U. S. NUCLEAR REGULATORY COMMISSION  
REGION I

Report No. 50-286/91-21  
Docket No. 50-286  
License No. DPR-64  
Licensee: New York Power Authority  
P.O. Box 215  
White Plains, New York 10511  
Facility Name: Indian Point Nuclear Power Station, Unit 3  
Inspection At: Buchanan, New York  
Inspection Conducted: November 12 - 22, 1991  
Inspectors: P. Drysdale, Sr. Reactor Engineer, DRS  
E. Conner, Project Engineer, DRP  
S. Wookey, Resident Inspector (Seabrook), DRP

Areas Inspected: This inspection was performed to review the current surveillance testing of the Safety Injection System, the Auxiliary Feedwater System, the Containment Air Recirculation and Filtering System, and the Safety Related Station Batteries. Surveillance test procedures were compared to design basis safety function requirements delineated in Design Basis Documents, the Updated Final Safety Analysis Report, and the Technical Specifications. The surveillance testing performed on these systems is one measure of their ability to perform satisfactorily, and to provide protection for public health and safety during abnormal plant conditions or events.

Figure A

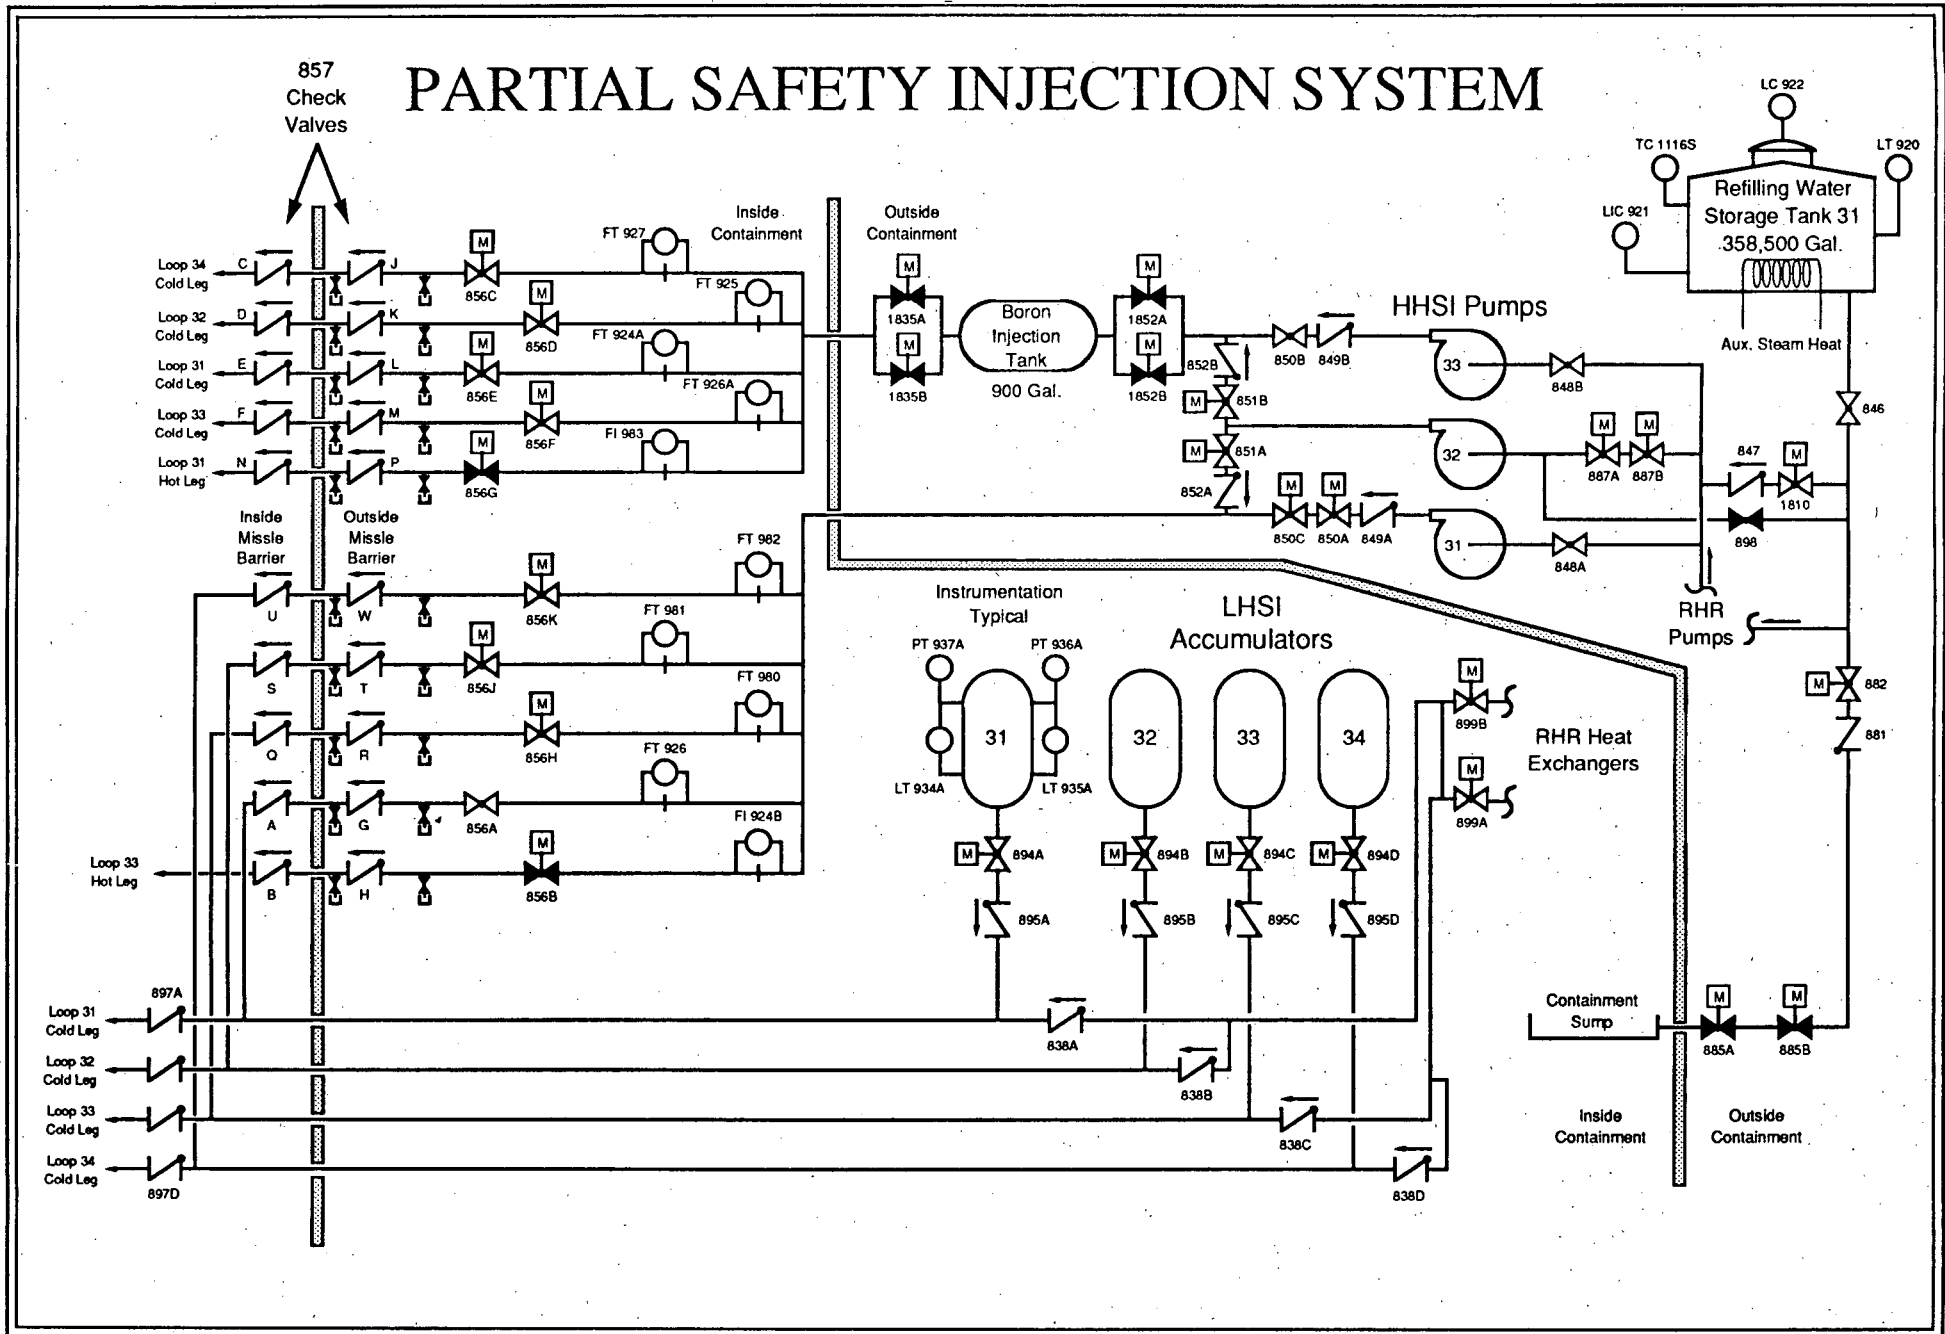
SAFETY FUNCTION	DESIGN BASIS REQUIREMENTS	FSAR DESCRIPTIONS/ BASES/EVALUATIONS	TECHNICAL SPECIFICATIONS	SURVEILLANCE TESTS AND PLANT PROCEDURES	NOTES AND COMMENTS
<p>Availability of full flow path from the RWST to the suction of HHSI pumps 31, 32, &amp; 33:</p> <p>Operational readiness of HHSI pump suction isolation MOVs 887A,B; pump recirc valves 842 &amp; 843; and pump suction header MOV 1810.</p> <p>Full flow capability of HHSI pumps suction check valve 847.*</p>	<p>DBD Sec 2.2.1.2: SIS active equipment shall be capable of being tested during normal operations to verify component operability. It is mandatory to make periodic tests on the safeguards pumps and to exercise essential valves iaw ASME Section XI</p>	<p>Sec 6.1: During the injection phase, the SI pumps do not depend upon any portion of other systems. [SI is accomplished only by the correct alignment and actuation of SIS components]</p>	<p>Sec 3.3.A.3.e: 3 HHSI pumps and their associated piping &amp; valves shall be operable when T-ave &gt;350°F</p> <p>Sec 3.3.A.3.i: Valve 1810 shall be open and its power supply deenergized when T-ave &gt;350°F</p> <p>Sec 3.3 Basis: MOVs 842 and 843 shall be open with power supplies deenergized to prevent spurious closure and overheating of the HHSI pumps. MOV 1810 is maintained open and its power supply is deenergized to assure flow from the RWST during the post-LOCA injection phase.</p>	<p>PT-CS8: Obtains and assesses IST data for MOV 1810 - full stroke seconds within acceptance criteria of ≤12 seconds.</p> <p>PT-R121: Test of #32 HHSI pump suction MOVs 887A &amp; 887B. Measures the opening and closing times for both valves. Also verifies the valve positioning in each test.</p> <p>ENG-431: Differential pressure test of HHSI pump supply MOV-1810 to demonstrate operability under actual d/p conditions.</p>	<p>Positions of all valves in this flow path are verified weekly. All manual valves are locked open.</p> <p>*Full flow capability of check valve 847 could not be verified; (URI 91-21-01)</p>

SAFETY FUNCTION	DESIGN BASIS REQUIREMENTS	FSAR DESCRIPTIONS/ BASES/EVALUATIONS	TECHNICAL SPECIFICATIONS	SURVEILLANCE TESTS AND PLANT PROCEDURES	NOTES AND COMMENTS
<p>Availability of HHSI non-BIT flow path to the RCS:</p> <p>Operational readiness of HHSI pumps 31 &amp; 32 discharge MOVs 850A, C and 851A;</p> <p>Full flow capability of HHSI pump 31 &amp; 32 discharge check valves 849A &amp; 852A, and non-BIT injection header check valves 857A, G, Q, R, S, T, U, &amp; W.</p>	<p>DBD Sec 2.2.1.2: SIS active equipment shall be capable of being tested during normal operations. It is mandatory to exercise essential valves iaw ASME Section XI</p>	<p>Sec 6.2.4: The TS establish limiting conditions regarding the operability of the system when the reactor is critical.</p>	<p>Sec 3.3.A.3.e: 3 HHSI pumps and associated piping and valves shall be operable when T-ave &gt;350°F.</p> <p>Sec 4.5.B.1.a &amp; b: The HHSI pumps shall be started at intervals not greater than one month. Acceptable levels of performance shall be that the pumps start, develop the required head on recirc flow, and operate for at least 15 minutes.</p>	<p>PT-M16: SI pump functional test; verifies that discharge check valve 852A opens (not a full stroke or full flow test). Measures open and close stroke times for MOV 850A &amp; C, and close time for MOV 851A.</p> <p>PT-R64: Performs a stroke test of HHSI non-BIT check valves 857A, G, Q, R, S, T, U, &amp; W; pump suction header check valve 847; and #31 &amp; #32 pump discharge check valves 849A and 852A. 857s must flow ≥100 gpm each; 849A &amp; 852A ≥400 gpm each; and 847 ≥650 gpm.*</p>	<p>Test data from performance on 11/28/90 was acceptable. However, adequate verification of full flow through check valve 847 not complete. (URI 91-21-01)</p>
